### Hot-Mixed Asphalt Pathway Construction, Extensions and Relocations

**Subject:** **Grandview Development along Auburn Road,  
Wetland Use Permit Review #6;  
Plans dated November 21, 2025  
ASTI File No. A25-0125.13**

# Reviewed plans 120825.pdf Markup Summary

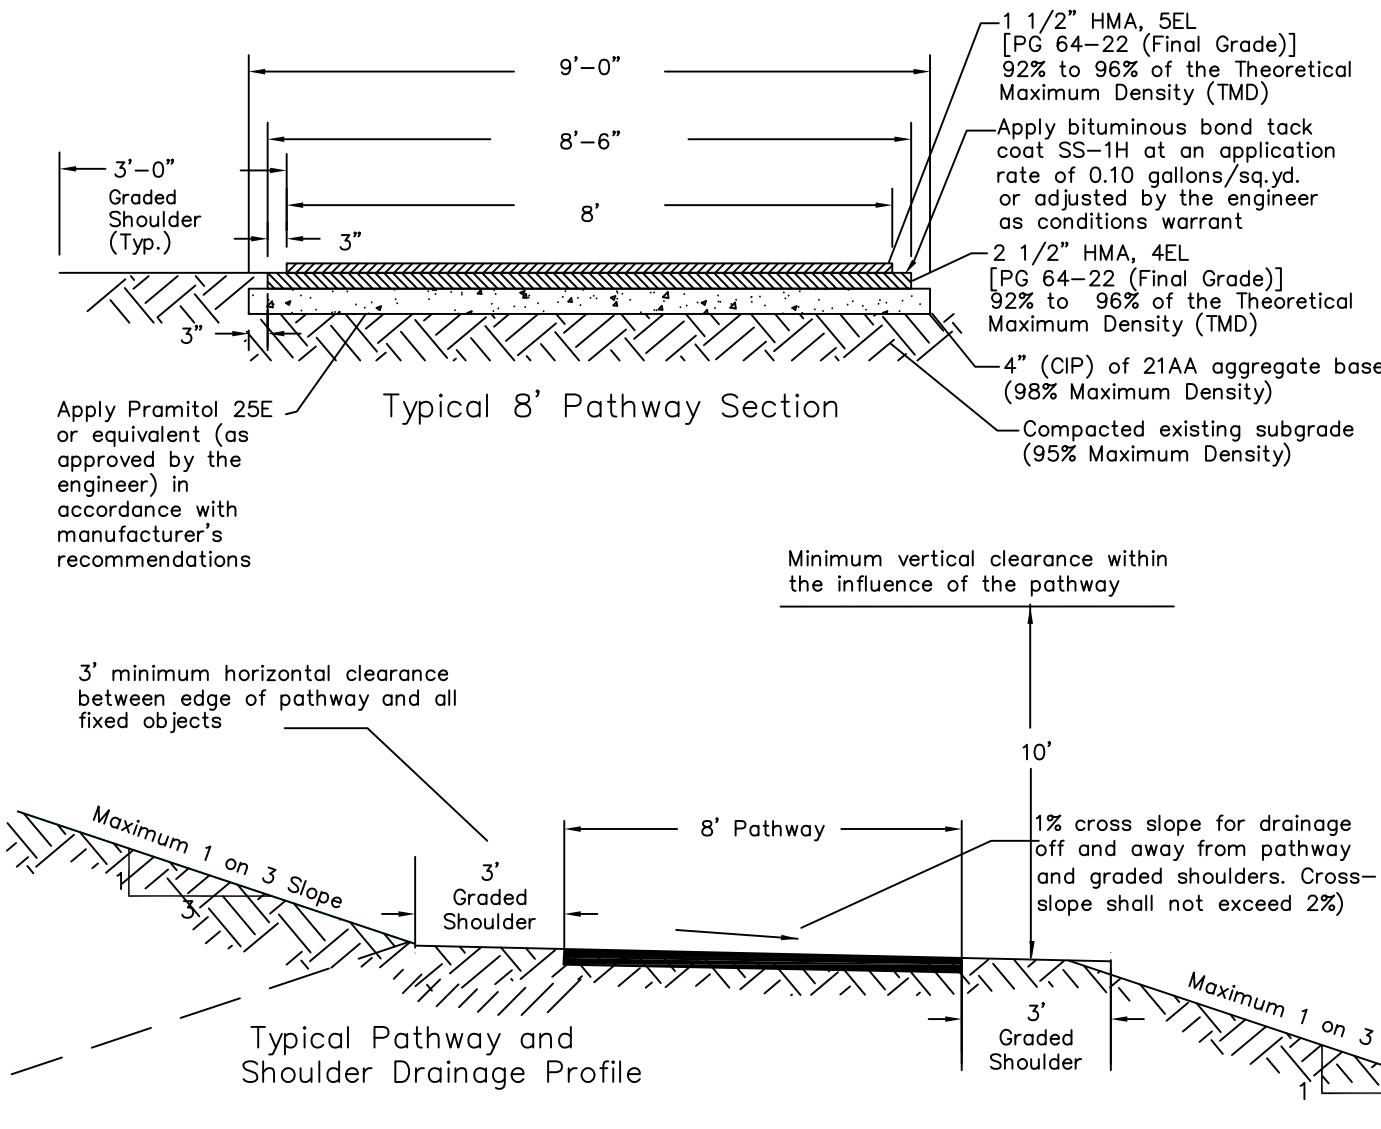
Use the updated Pathway Detail (recent changes to the notes)

Add revised Pathway detail
